## December 13, 2024

## City of Coahoma, TX USDA Rural Development Wastewater Lagoon Improvements Addendum No. 1

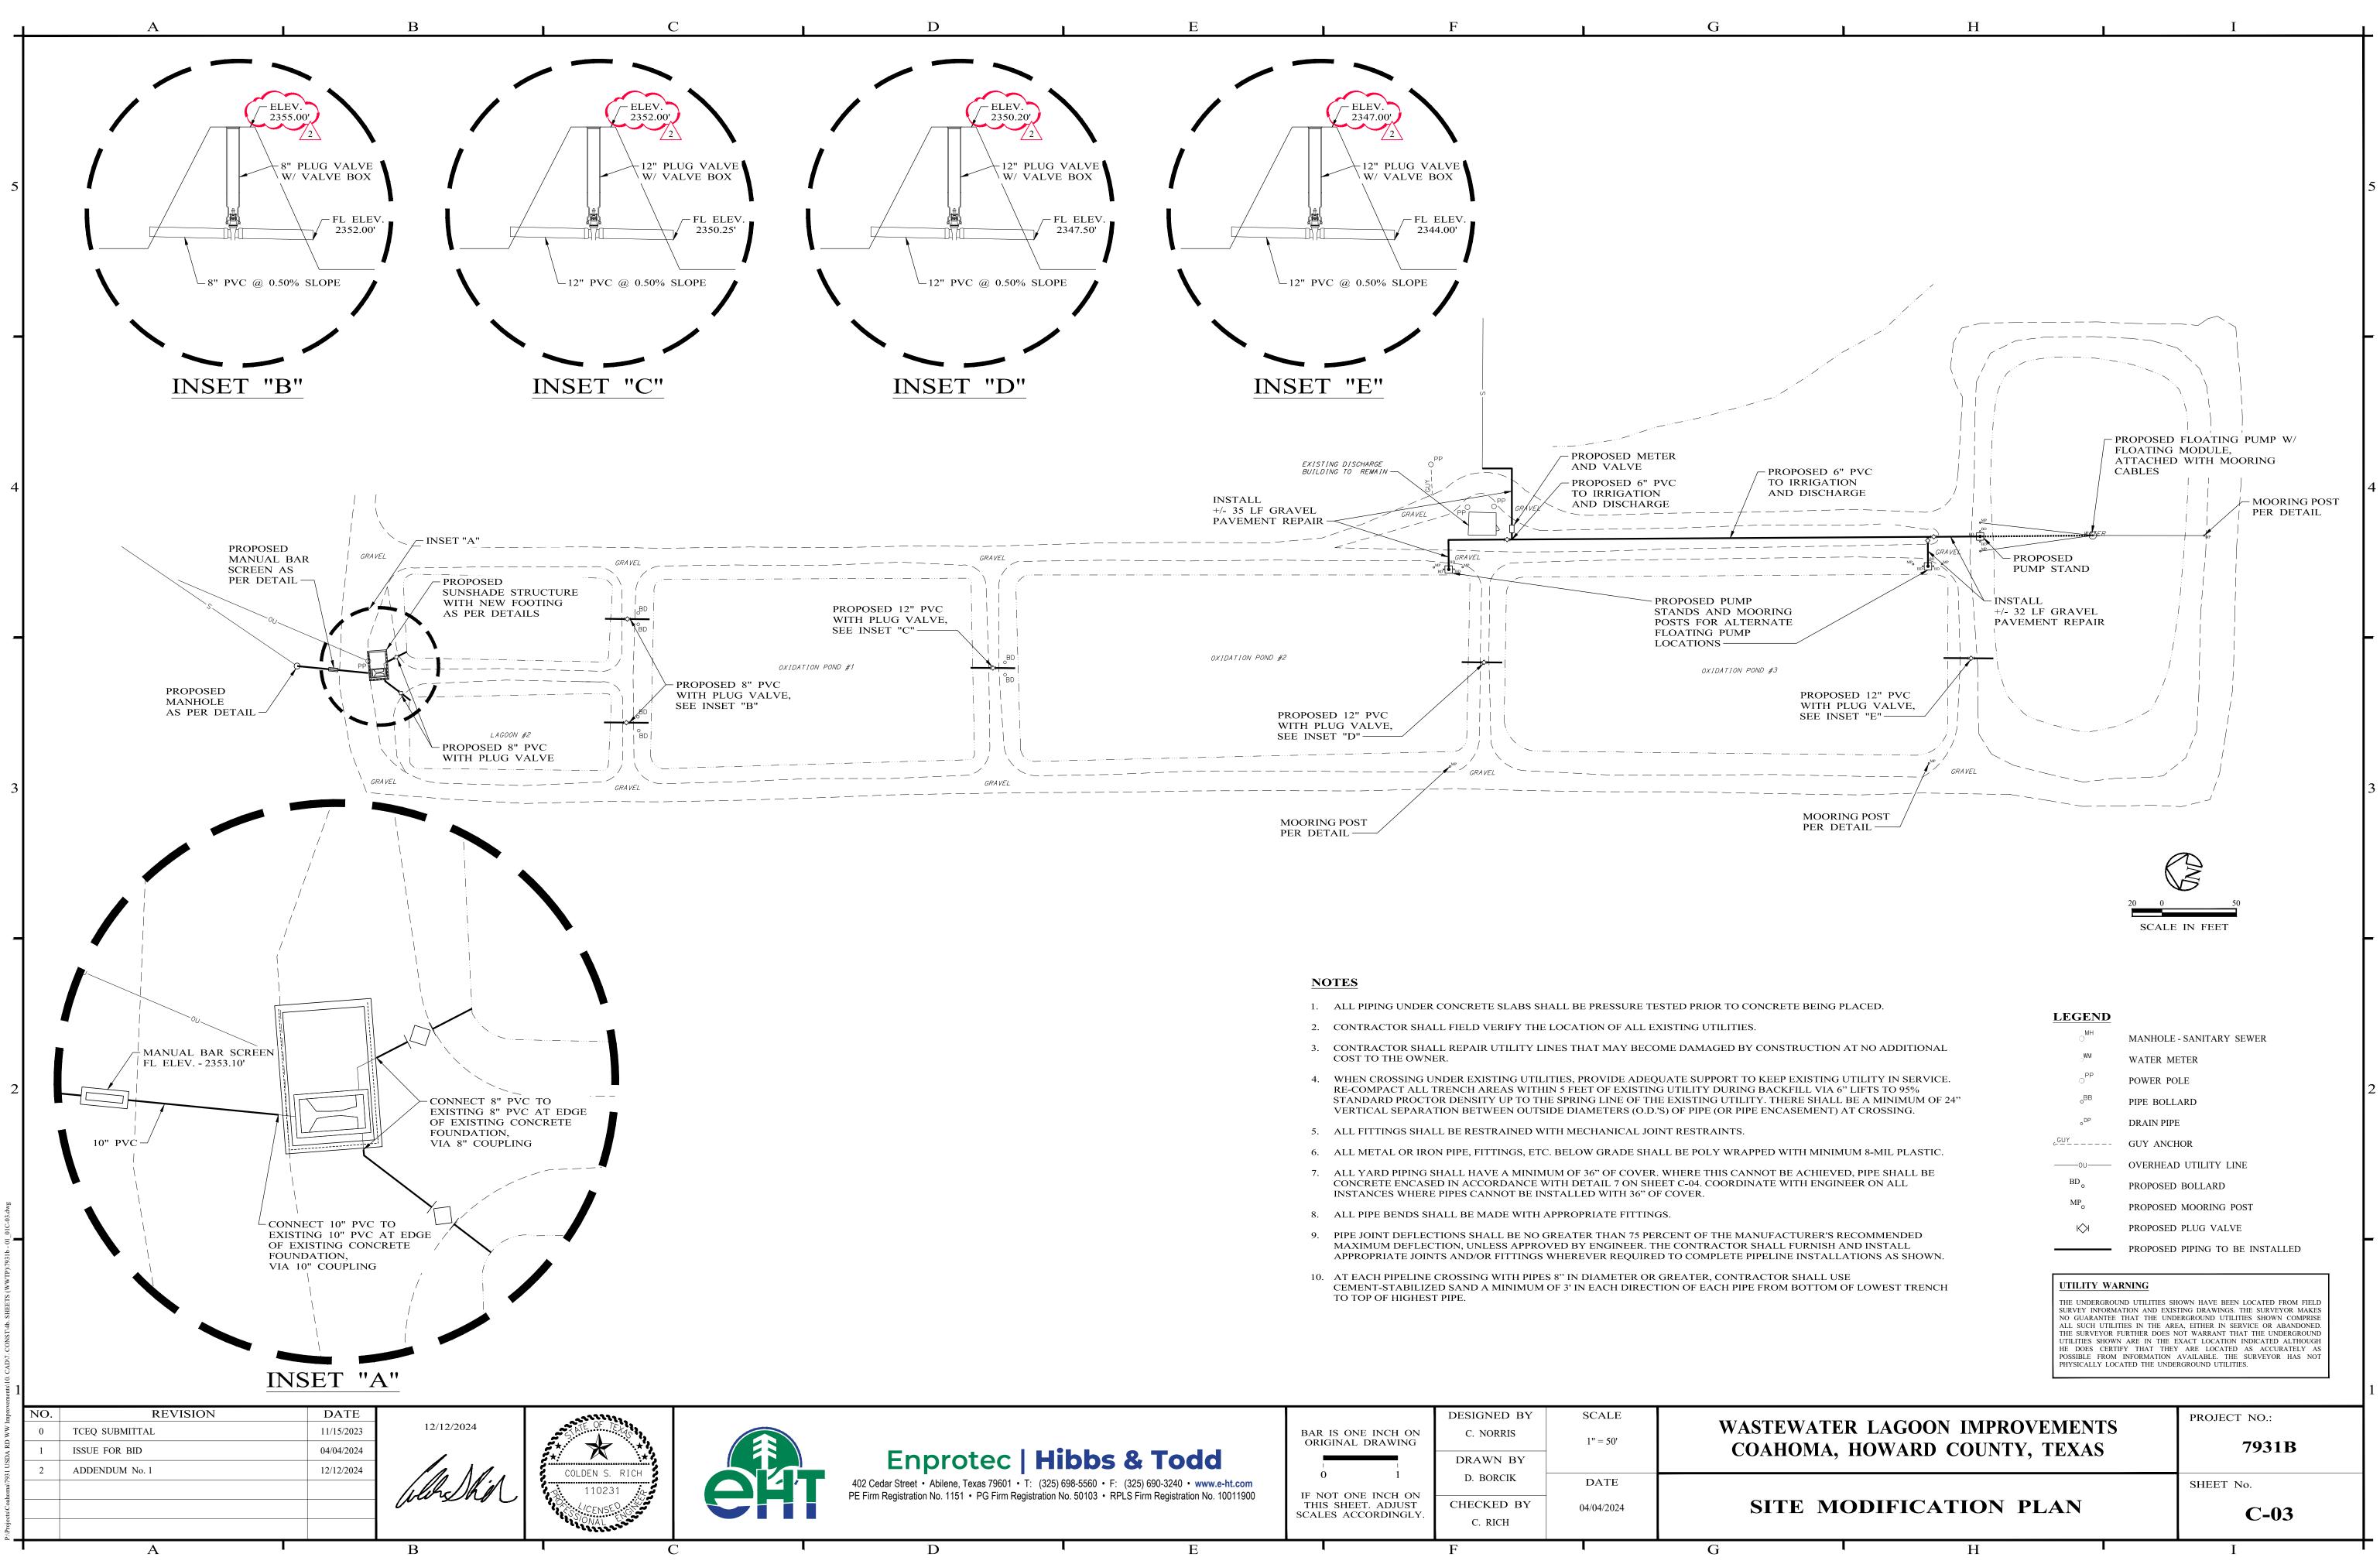
**CLARIFICATION TO BIDDERS:** The following comments by the engineer are shared with bidders to use however they deem fit in the bidding process.
